ADDENDUM NO.: ONE (Meadow Homes)

PROJECT: BID #1940 Modernization of Three Elementary School Campuses, Phase 1

ADDENDUM NO. 1

Project: Mt Diablo Unified School District
Meadow Homes Elementary School
Increment 1
19six #: 23119
DSA #: 01-121400 File #: 07-29

SITE PLAN - CODE ANALYSIS | 1" = 30'-0" | 1

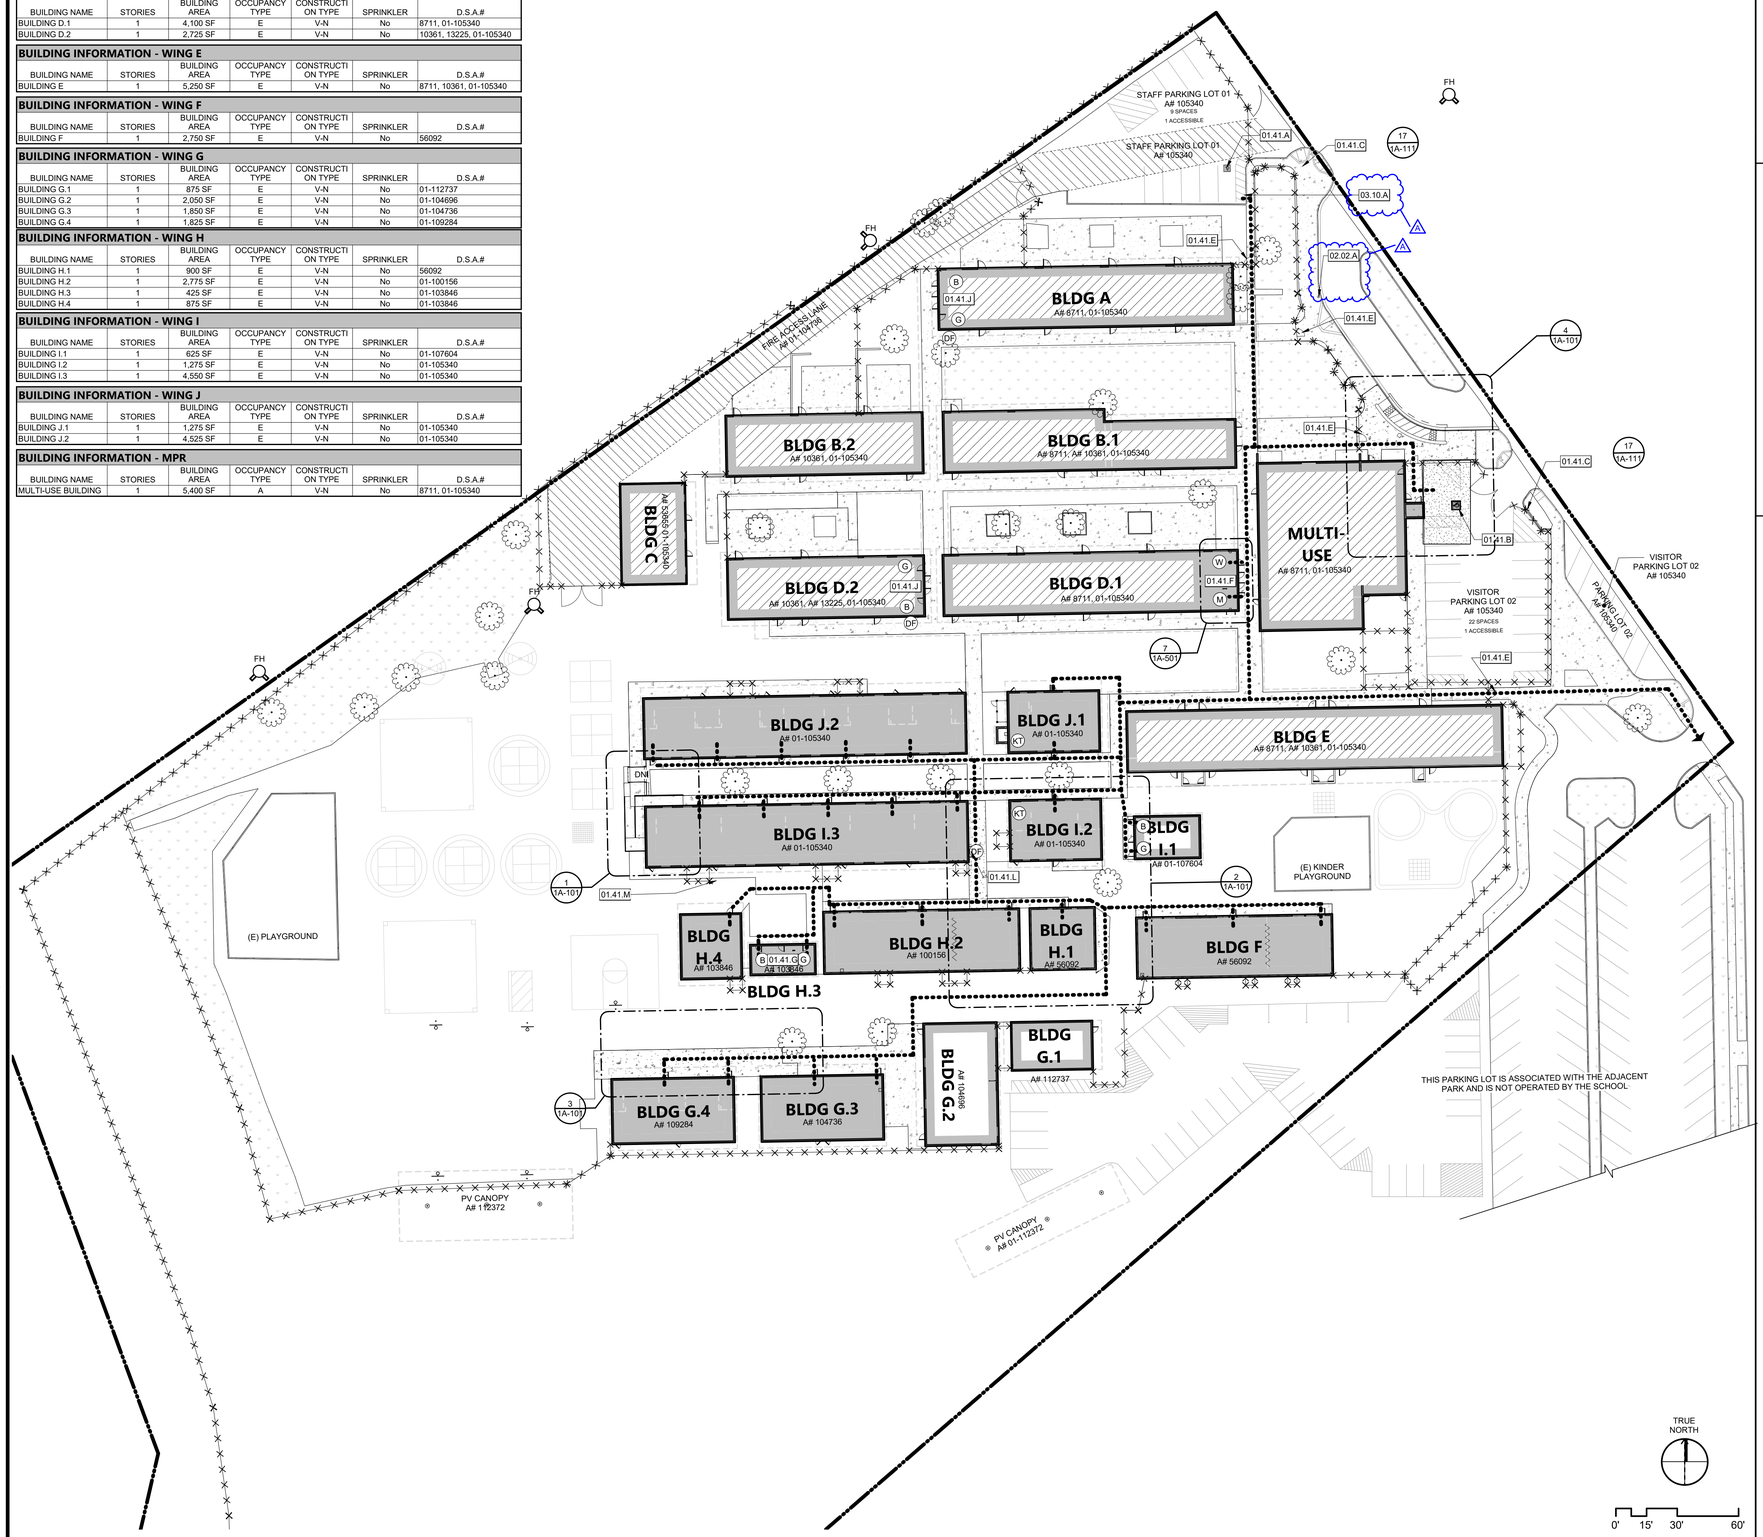
ITEM 1. 1G-100 CODE SITE PLAN
- Added keynote 03.10A
- Added Keynote 02.02.A
- Edited Keynote 01.41.L

01.41.A	(E) ACCESSIBLE PARKING STALL A#01-105340
01.41.B	(E) ACCESSIBLE VAN PARKING STALL A#01-105340
01.41.C	(E) TOW SIGN A#01-105340. SEE DETAIL 17/1A-111. FOR REFERENCE ONLY.
01.41.E	(E) ACCESSIBLE EGRESS GATE W/ PANIC HARDWARE. SEE DETAIL 3/1A-111. FOR REFERENCE ONLY
01.41.F	(E) ACCESSIBLE STAFF TOILET ROOM A#01-103846
01.41.G	(E) ACCESSIBLE STUDENT TOILET ROOM A#01-103846
01.41.J	(E) ACCESSIBLE STUDENT TOILET ROOM A#01-115297
01.41.L	(N) HI-LO ACCESSIBLE DRINKING FOUNTAIN SERVING AREA OF WORK (SEE DETAIL 20/1A-111)
01.41.M	(E) ACCESSIBLE RAMP A#01-105340
02.02.A	REMOVE "BUSES ONLY" PARKING SIGN & POST
03.10.A	(E) FLASH CURB

DRAINAGE & GRADING PLAN

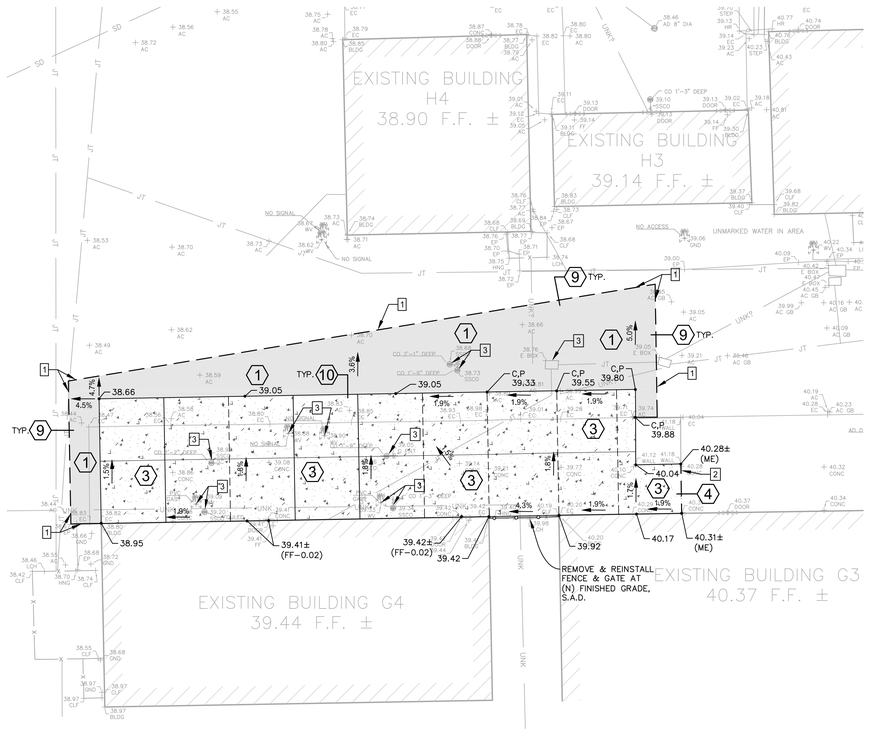
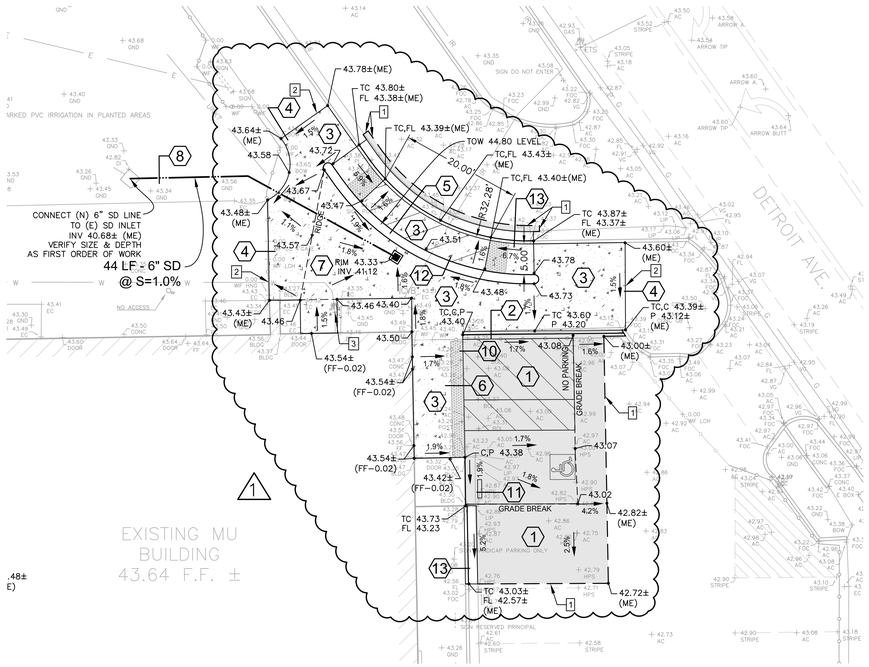
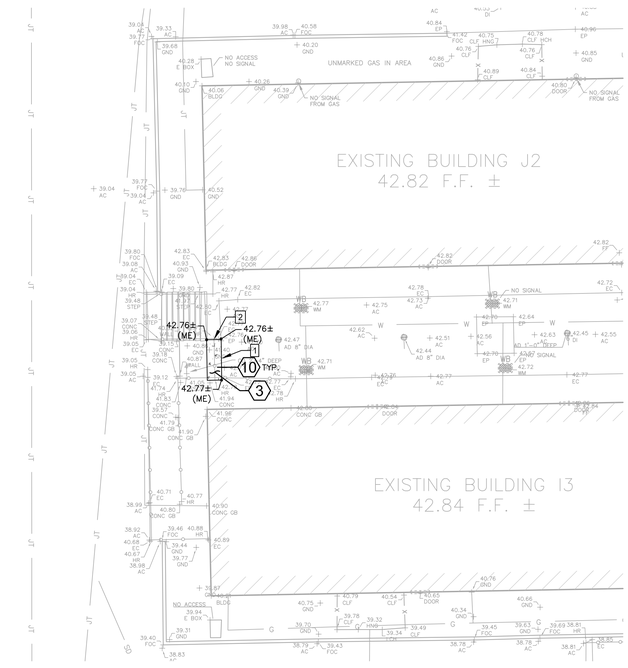
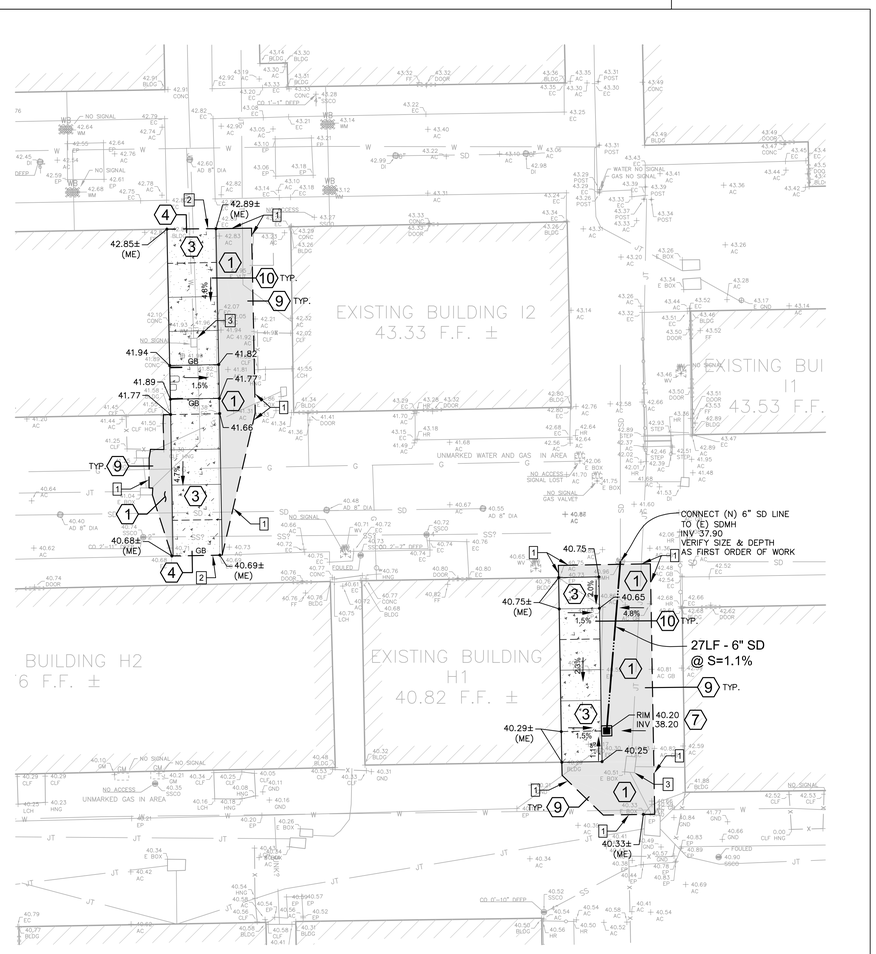
ITEM 3. 1C2.1 DRAINAGE & GRADING PLAN
- Revision to ADA parking stall size

ENLARGED SITE PLAN - SITE REPAIR AREA 4 | 1/8" = 1'-0" | 4

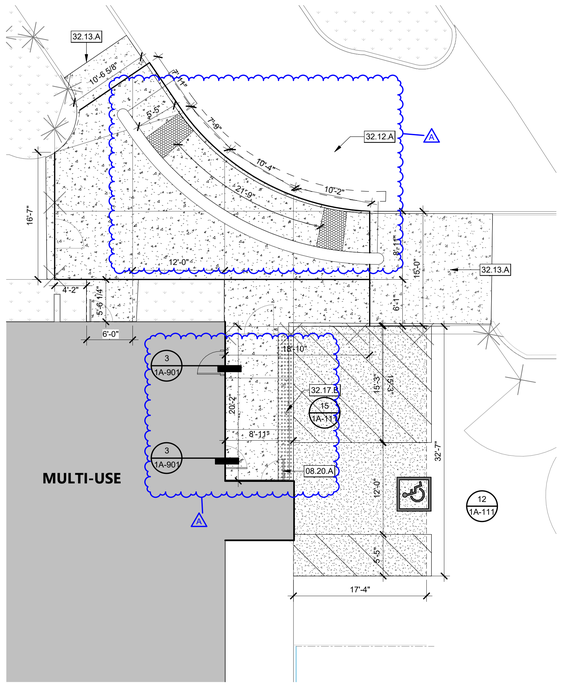
ITEM 4. 1A-101 ENLARGED SITE PLAN
- Modified Enlarged plan 4 to show dimensions and added detail sections to add (2) new thresholds at existing MPR Building

ADA PARKING | 3/16" = 1'-0" | 12

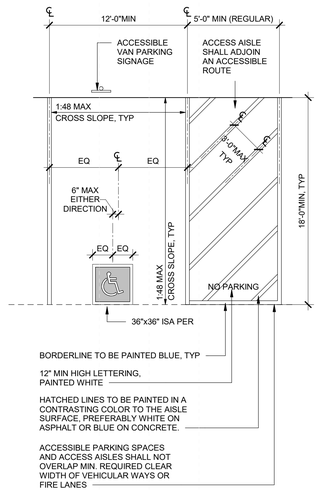
ITEM 5. 1A-111 SITE DETAILS
- Modified detail 12, striping layout updated to meet code compliance.

ENLARGED PLAN - STAFF RESTROOMS T3 & T4 | 1/4" = 1'-0" | 7

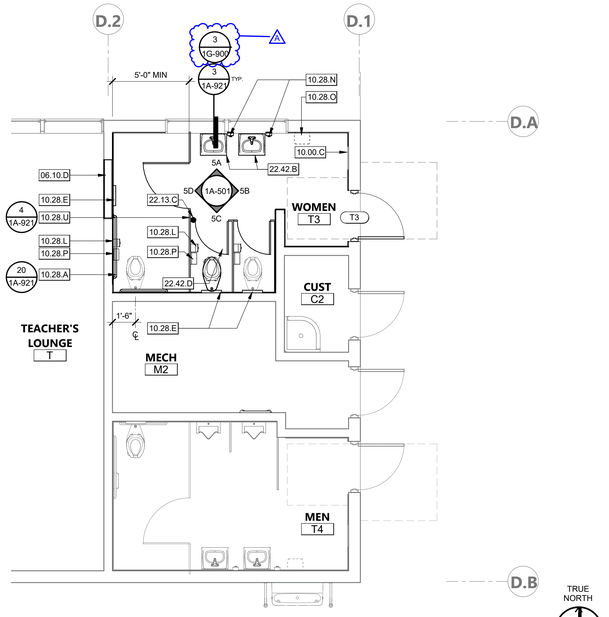
ITEM 6. 1A-501 ENLARGED PLANS
- Added detail call out for mounting heights for Adult lavatory, applies to details 5 & 7. (for information only)

T7 & T9 CLEARANCE FLOOR PLAN | 1/4" = 1'-0" | 3

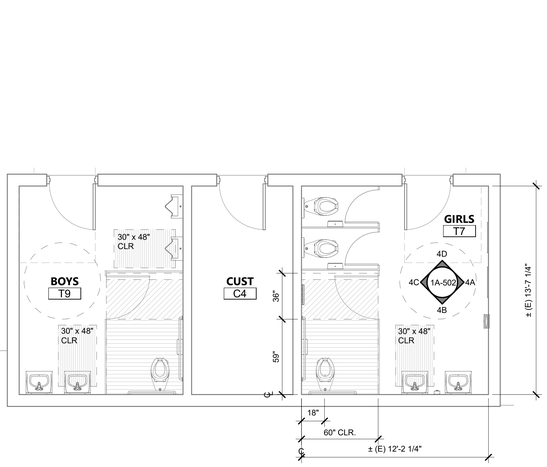
ITEM 7. 1A-502 ENLARGED PLANS
- Reversed door swing on restroom K-1B
- Added Keynote 02.51.A
- Updated RR Elevations T7 & T9 to indicate code compliance (for information only)

02.51.A REMOVE (E) ACCESSIBLE SIGNAGE

TYPICAL CLASSROOM ELEVATIONS - J.2 | 1/4" = 1'-0" | 1

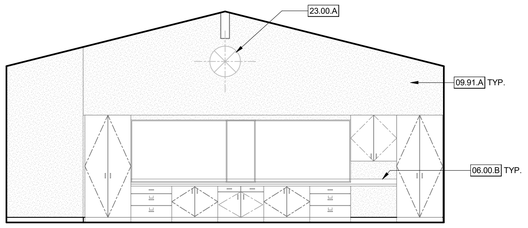
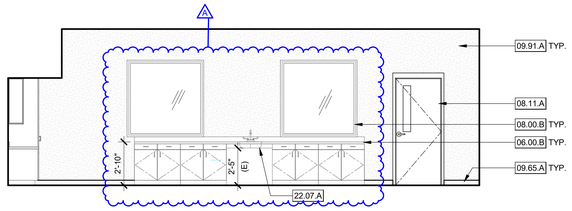
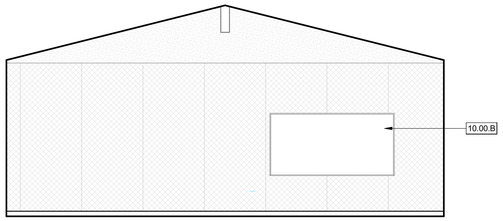
ITEM 8. 1A-601 INTERIOR ELEVATIONS
- Modified interior elevation to show compliance (for information only)

DOOR TYPE 'A' **DOOR TYPE 'B'**

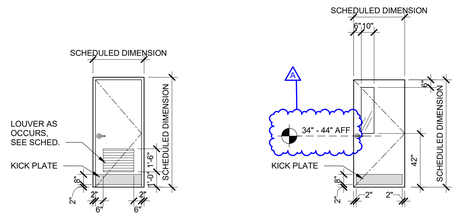
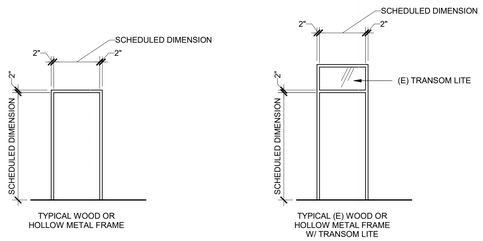
ITEM 9. 1A-801 DOOR SCHEDULE
- Updates to Door type B showing mounting height of door hardware (for information only)

LAVATORY MOUNTING | 1" = 1'-0" | **3**

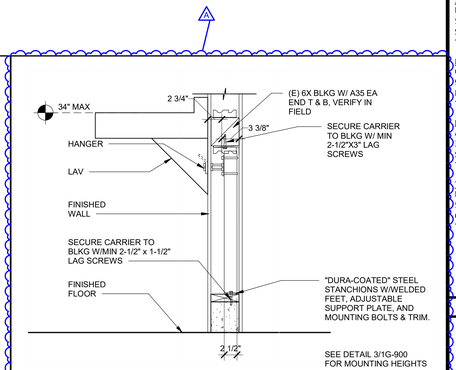
ITEM 10. 1A-921 INTERIOR DETAILS
- Revision of detail 3 to show mounting height per code
